8.1 DA 2018/381 - Lot 2, DP 1065811, 404 Old Byron Bay Road, Newrybar.DOC

Development Application Assessment Form*(Pursuant to s 4.14 and s.4.15 (1) of the EP & A Act 1979)***Application Details**

Development Application No.	2018/381
Property Description	Lot: 2 DP: 1065811, 404 Old Byron Bay Road NEWRYBAR
Proposed Development	Decommissioning of an existing dwelling and construction of a new dwelling and swimming pool and upgrade of an internal vehicular access way
Building Classification	1a, 10a & 10b
Site Inspection Date	5 April 2019

Proposed Decommissioning Floor Plan

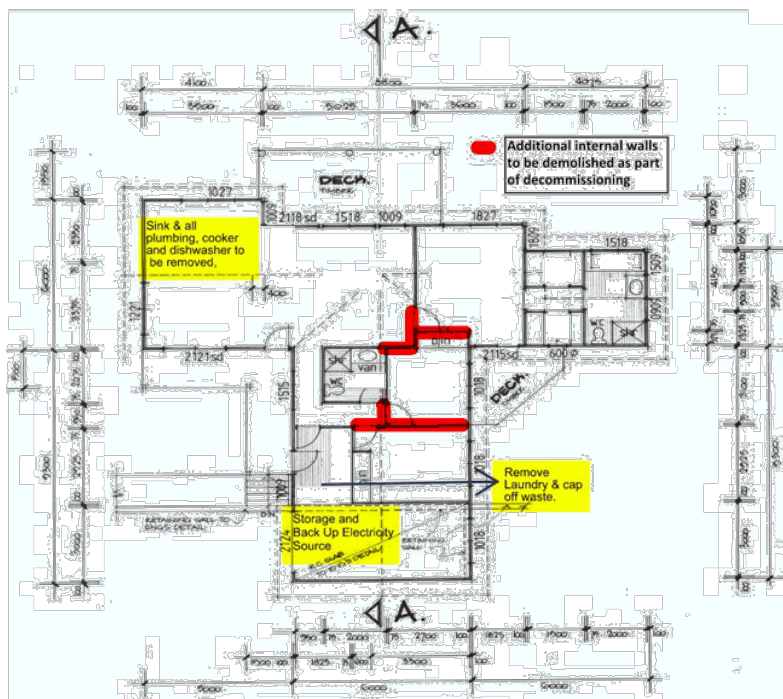
The current proposed work to decommission the existing dwelling house is insufficient to conclusively surrender the habitable status of the building. If approval is to be granted, further decommissioning works should be required to be carried out that will result in a building that cannot be easily re-configured or adapted for use as a dwelling without obtaining development consent. In order to achieve

this, it is recommended that the some internal walls be demolished to create a more open style floor plan that would be unlikely to be used as separate rooms for a residential use.

Additional internal walls recommended to be demolished

- *Prior to issue of a Construction Certificate, a plans depicting the decommissioning works to the existing dwelling are to be submitted to and approved by Council.*

Figure 8: Internal Access Way with Biodiversity Value Map Overlay

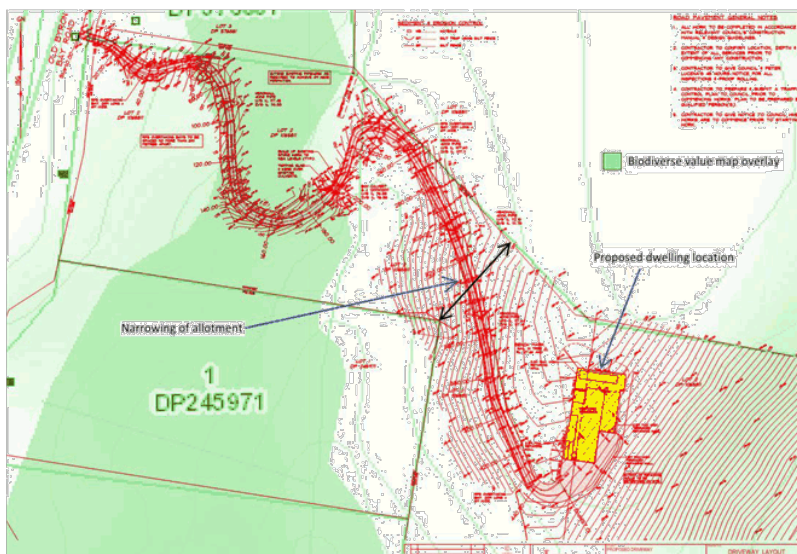
The internal access way linking the development site to Old Byron Bay Road has been constructed without prior Council approval. This vehicular access way incorporates a concrete culvert water crossing and transverse through a portion of land with Bio-diversity values, which is mapped by the Department of Planning, Industry and Environment under the Biodiversity Conservation Act 2016 (BC Act). See Figures 8, 9 and 10.

As part of the access works, the landowner installed box culverts over an intermittently flowing creek. It would appear culverts were installed without having regard for the ecological flow requirements of the creek. The base level (invert level) of the culverts is too high and, as such, restricting the natural flow of the creek. To address this matter the landowner will be required to remove and reinstall the culverts to reinstate the natural hydrology. If approved, this could be enforced by a condition to the effect that:

- *Within three months of the issuing of this Consent the applicant is to submit to Council for approval a Culvert Replacement Plan (CRP). The purpose of the CRP is to ensure the natural flow regimes of the creek which, traverses the approved internal driveway are restored to their predevelopment state. The CRP is to be prepared by a suitably qualified professional to address the following matters:*

- *based on the results of the survey data include detailed design plans to ensure all low flow events from the creek can pass through the culverts unimpeded*

Plate 1: Extended restoration program. Orange hatched polygon depicts planting area while the yellow line represents the boundary of required restoration works.

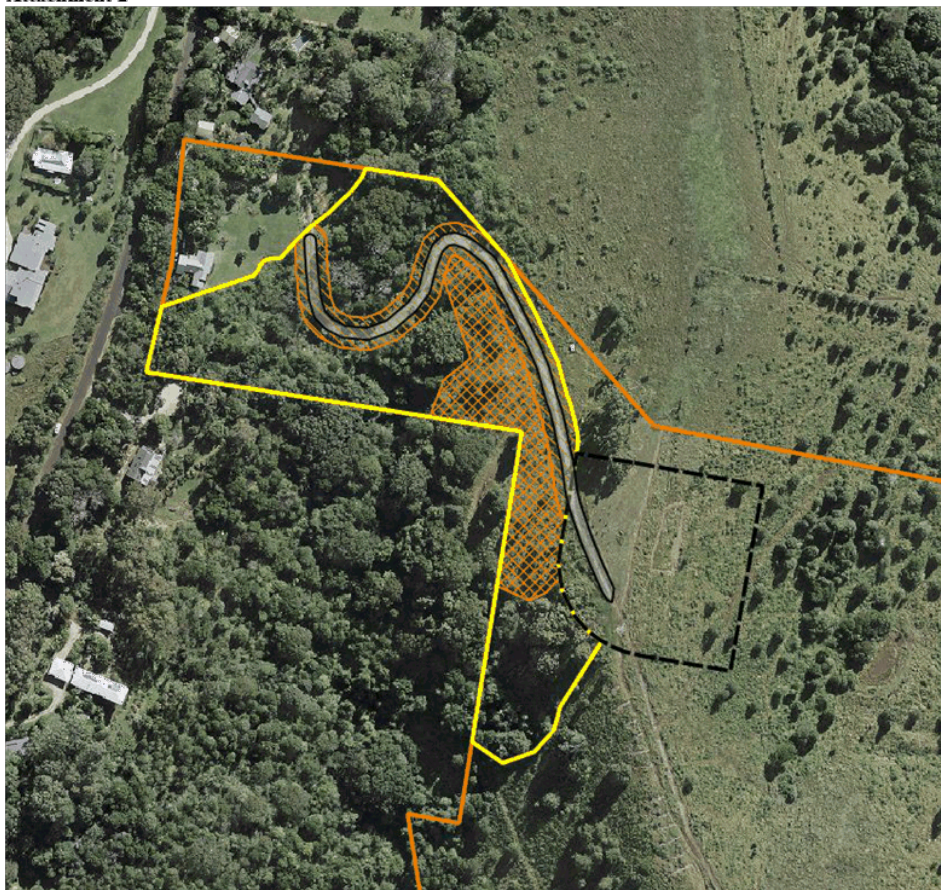
- *Extension of the rainforest restoration program to include the area of land depicted by the orange polygon in Attachment 2 (as below). The edge of the extended rainforest planting program is commence 5 meters from the edge of the internal driveway access.*

- *Shrubs and native groundcovers only – planted within the first 5 m of internal access to filter weeds, capture sediment run-off and minimize maintenance burden for emergency and daily access.*
